Addendum #1	County	Adams
	Local Public Agency	Quincy
September 7, 2016	Project Number	MR 599B
	2016 Capital Roadway Improvements – Wards 4 and 7

2016 Capital Roadway Improvements – Wards 4 and 7

This addendum forms a part of the bidding and contract documents and modifies the original bidding documents dated September 1, 2016. Summary of changes:

CITY OF QUINCY PROJECT NO. MR-599B	TOTAL SHEETS	SHEET NO.
JOB NO. 14706	44	24

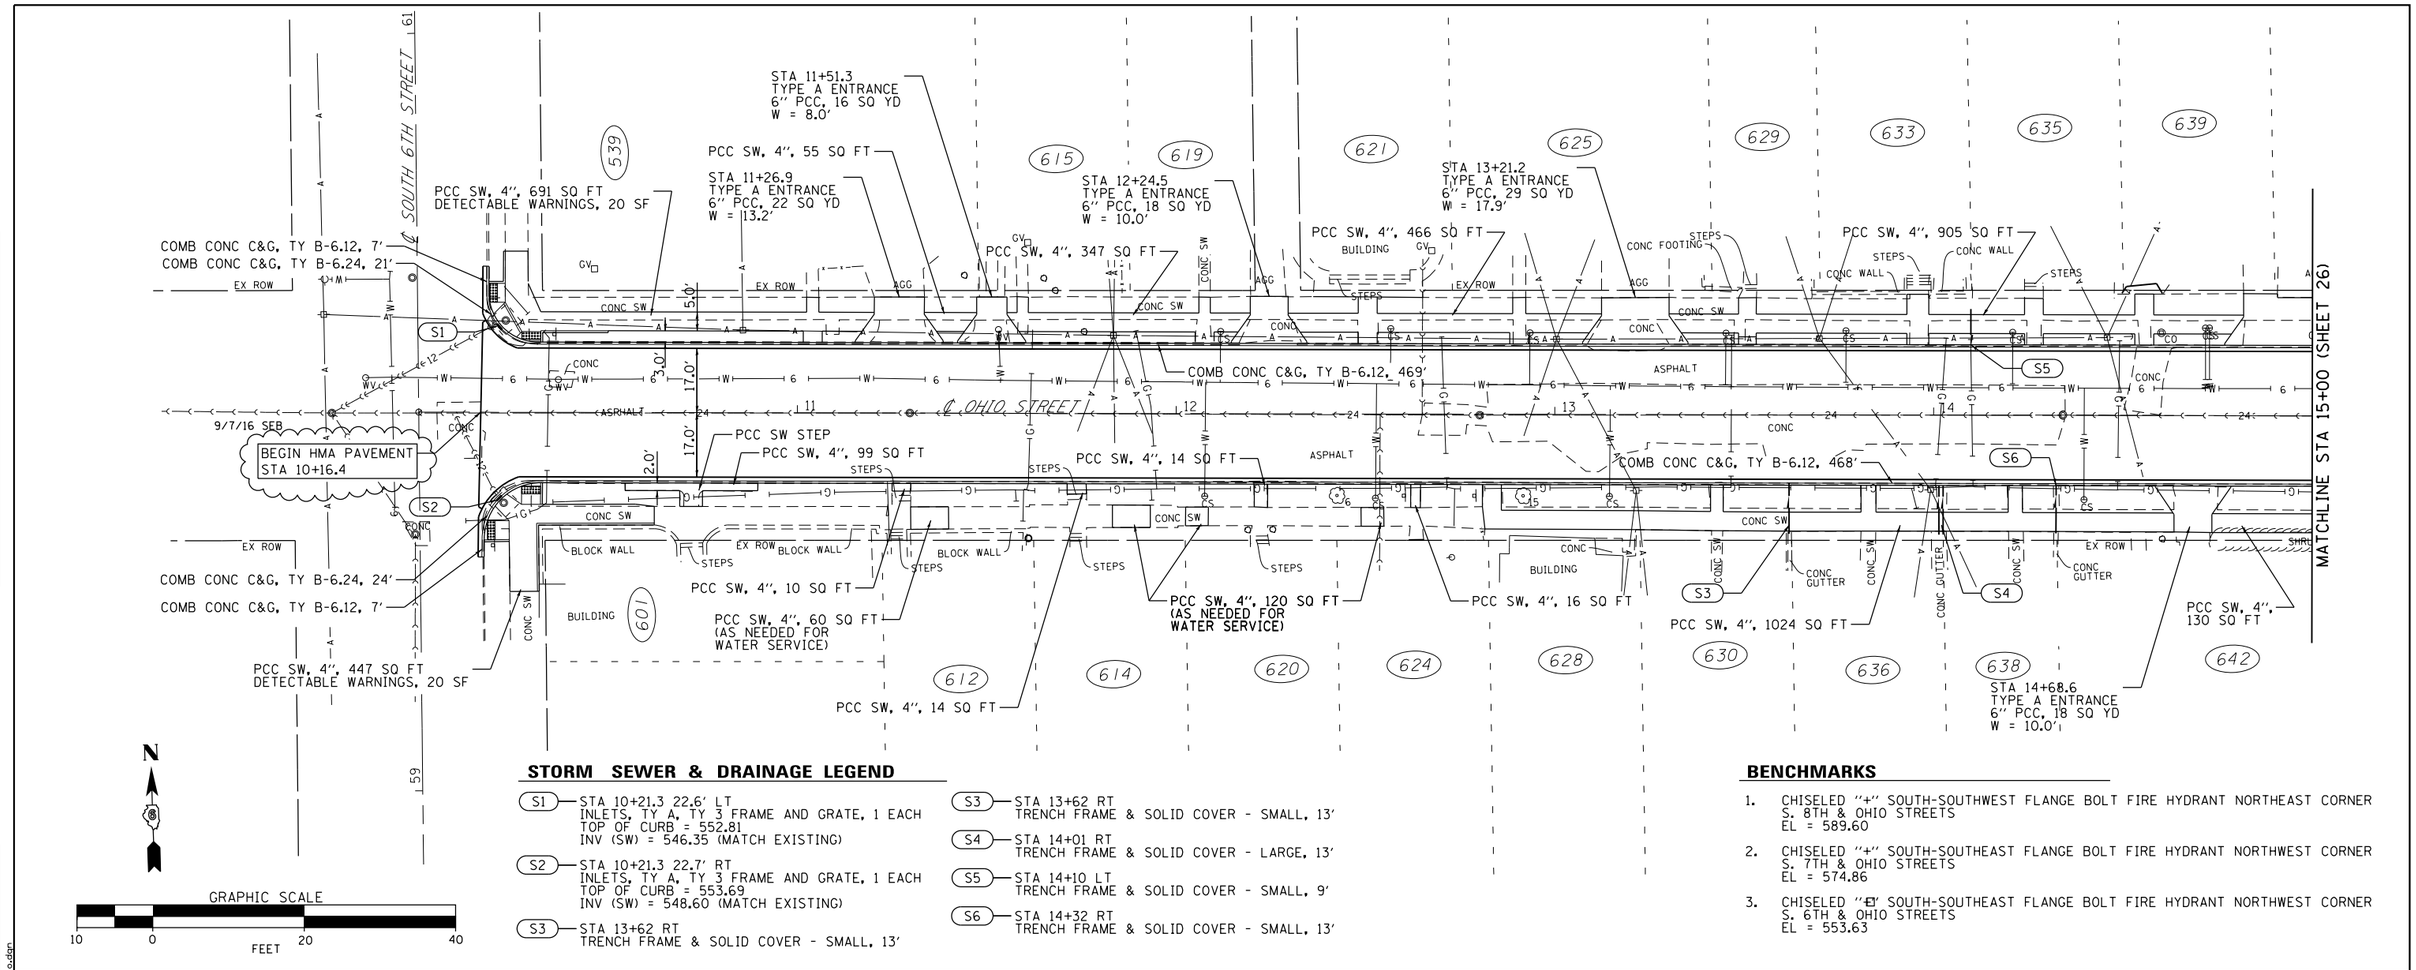
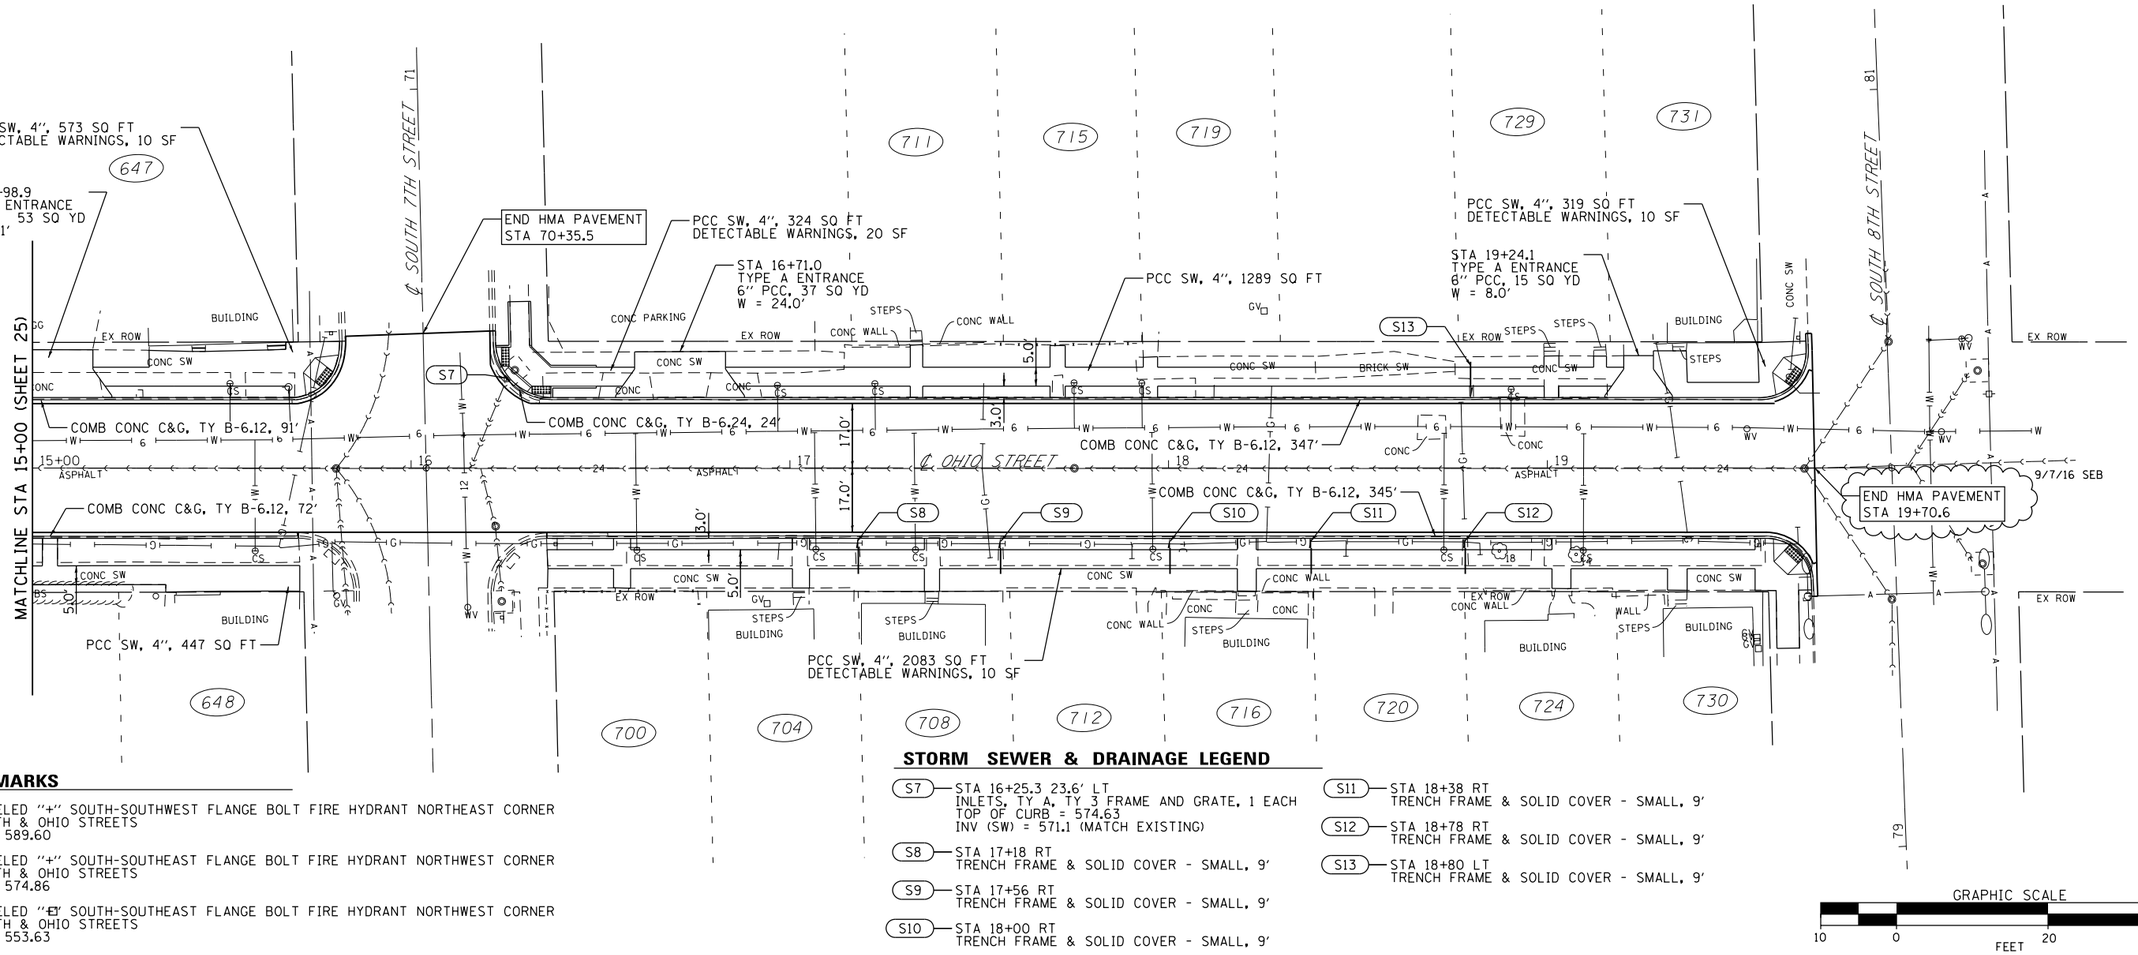
6. **SHEETS 24-27 of 44** - Extended project limits to include milling and resurfacing into South 6th and South 8th streets.

TOTAL SHEETS	SHEET NO.
44	41

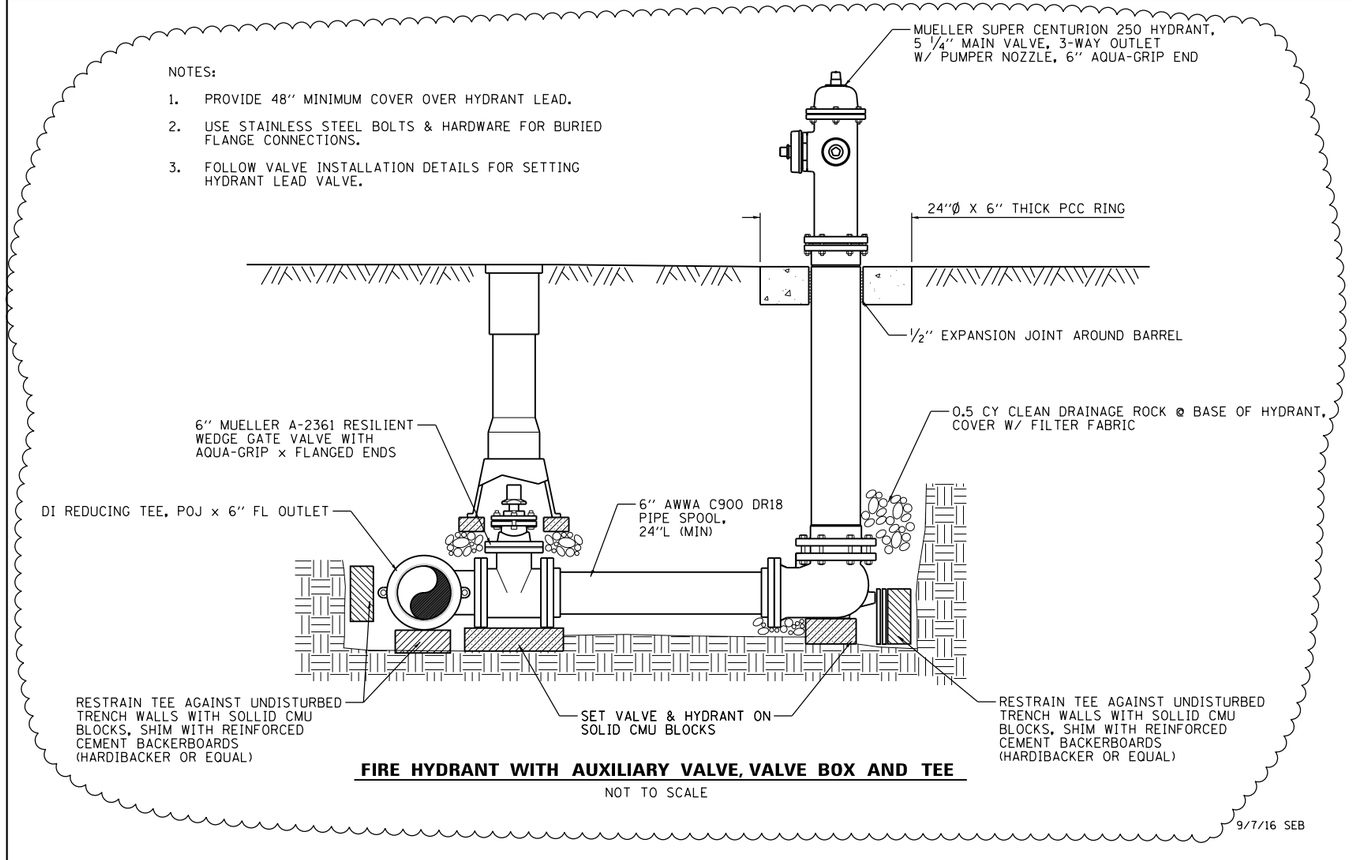
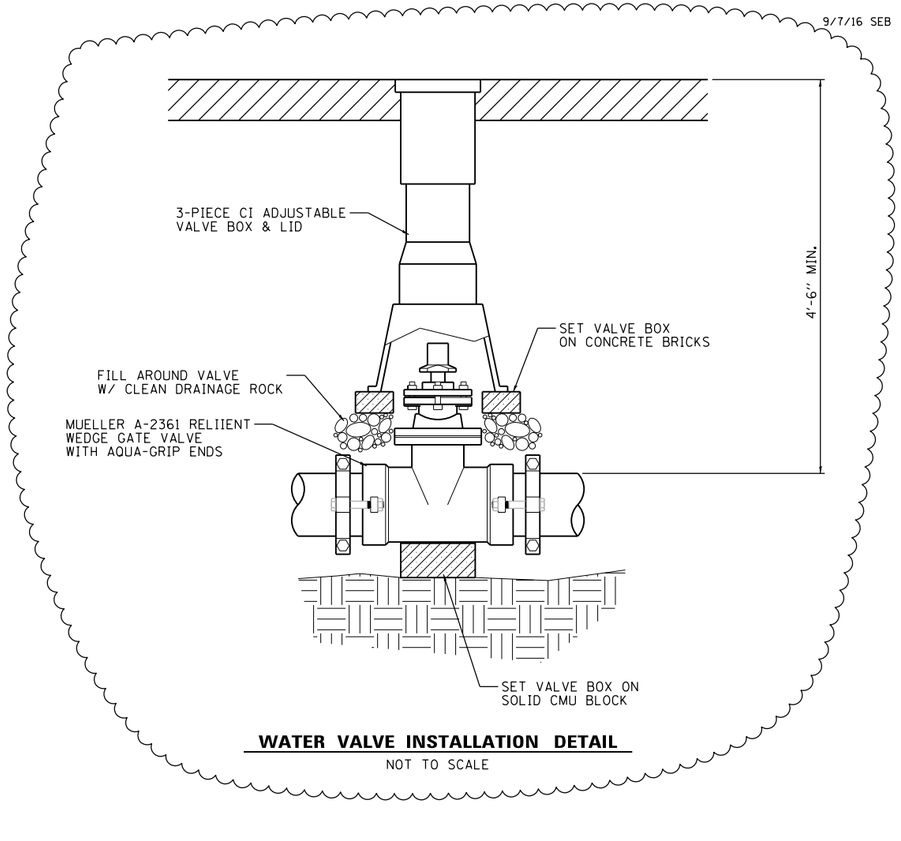
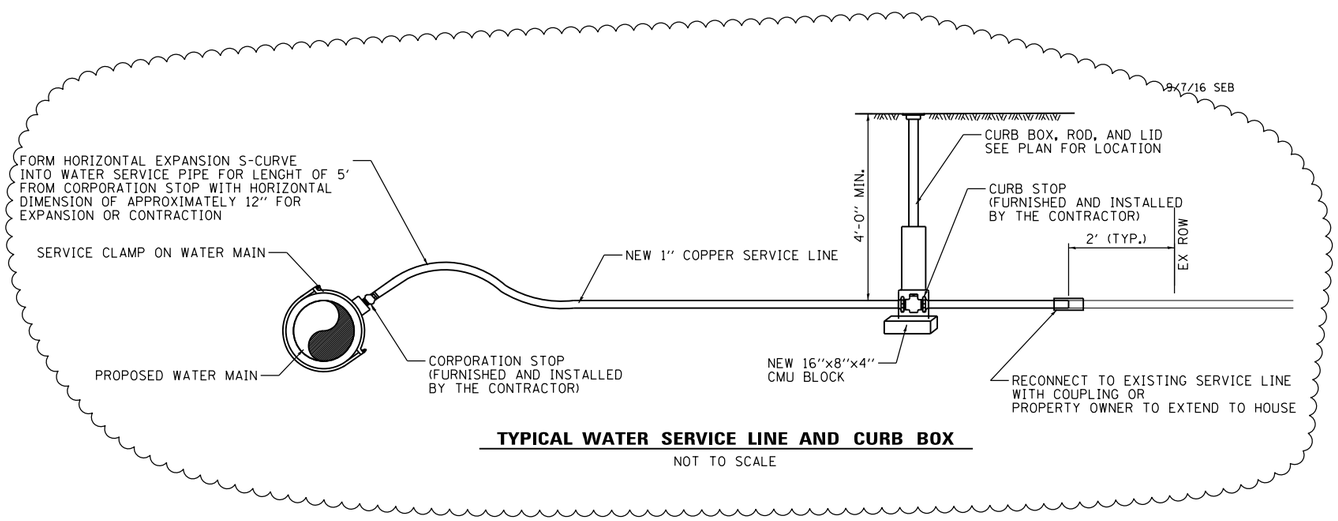
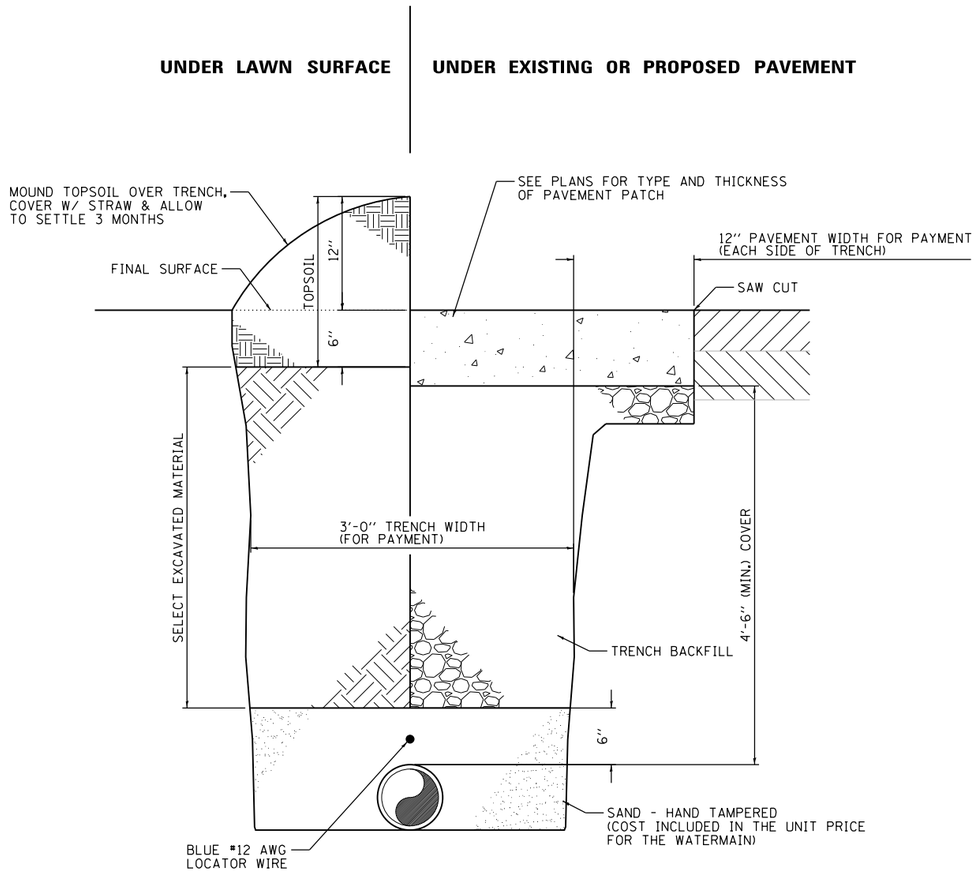
7. **SHEETS 37 & 41 of 44** - Updated water main plan and details.

TYPICAL SANITARY SERVICE REPLACEMENT

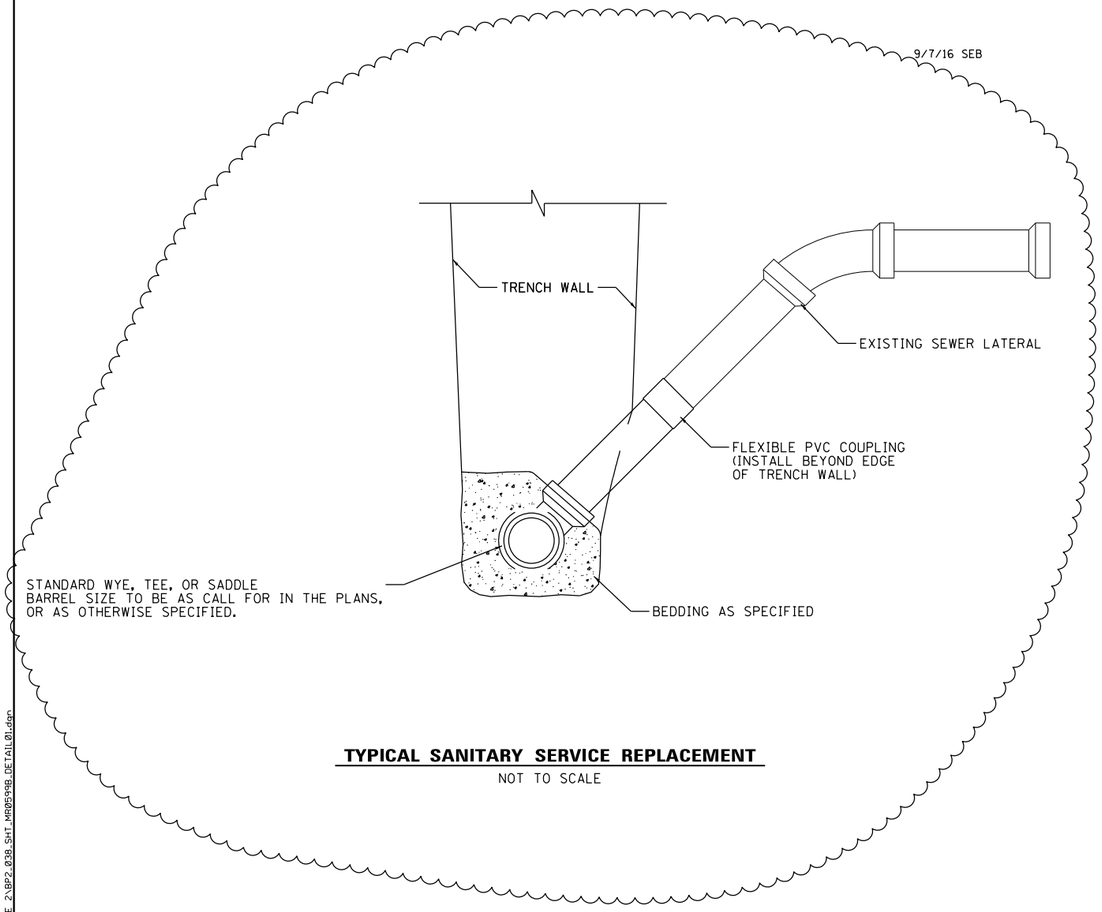
8. **SHEET 44 of 44** - Clarified limits of sewer service replacement ot just outside of the trench wall.
